The following are responses to questions submitted in e-mail dated 6/11/10:

**Q. Impacts of construction of the 220 kV gen-tie structure and the fiber optic cable.**

## Cemco, Inc. 3 Bin Batch Plant

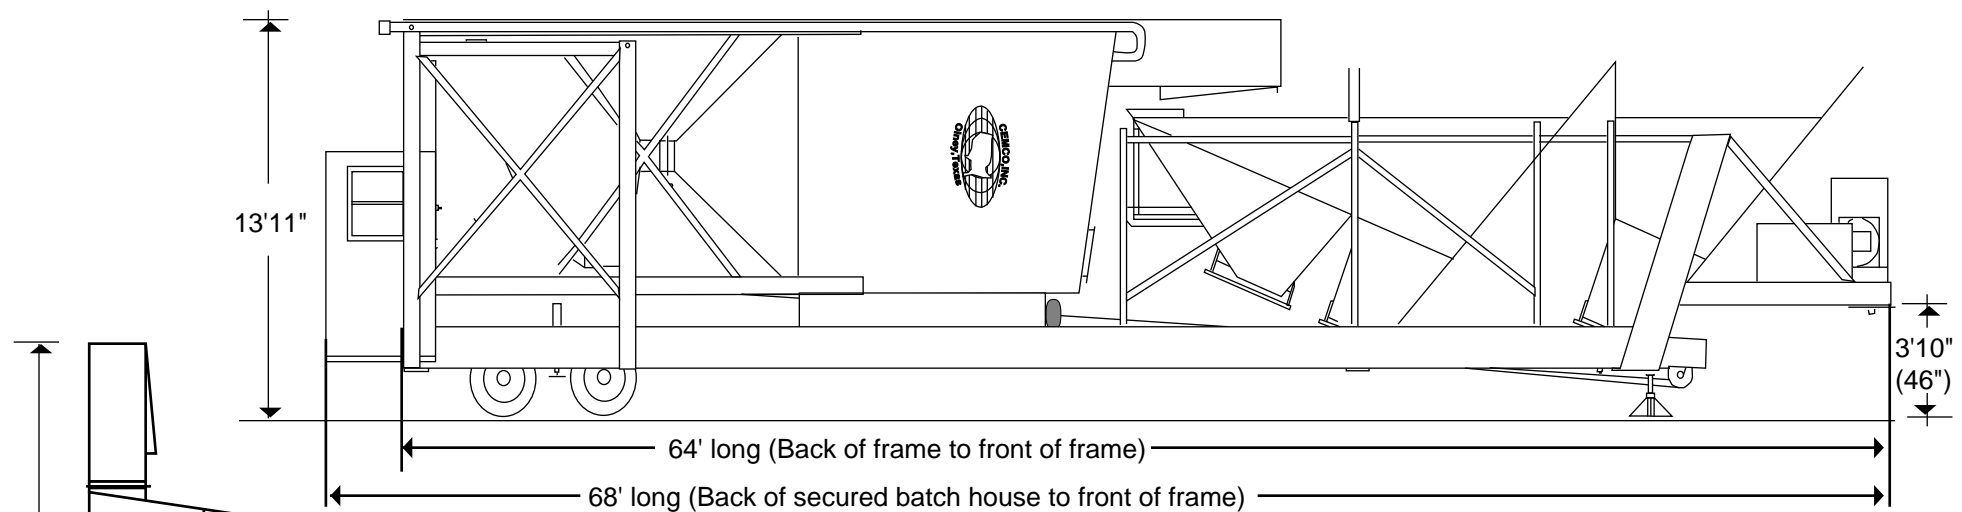
**Q. Concrete Batch Plant.** Since this facility will operate at night, noise and night-lighting impacts may occur to wildlife species. We need the night-time decibel range and hours of operation that the facility will generate and design measures that will be implemented to mitigate the temporary noise and lighting impacts from operating the concrete plant during construction. We also need a more detailed plan of the concrete batch plant than that shown in the Preliminary Site Plan Exhibit. Show the exact dimensions of the proposed batch plant in relation to the entire facility footprint.

A. Night operation of the batch plant will vary by season due to temperature requirements for concrete to set. In the summer, concrete needs to be produced and poured at night. While in the winter, concrete must be produced and poured during the day. The batch plant will operate 10 hours per day. Summer operation of the batch plant will occur in the range of 10pm-10am. Winter operation of the batch plant will occur between 4am-6pm.

As noted in the Engineering Changes document filed with the SA/DEIS Comments on April 19, 2010, noise from the batch plant when it is operating is expected to be 90 dB at a distance of 50 feet from the batch plant. The Engineering Changes document also indicated five temporary locations for the mobile batch plant within the site. Of these five temporary locations, #2 is the closest to any fenceline, at a distance of 1,100 feet. Based on that distance, the noise from the batch plant at the fenceline would be approximately 64 dB, below the normally applied threshold of 65 dB. The batch plant would only be in this location during the construction of the northwestern solar field (Unit #2). At the other four temporary batch plant locations will generate noise levels at the fenceline at a range between 54 and 64 dB.

Copies of standard batch plant design/specifications that will be used for BSPP are attached.
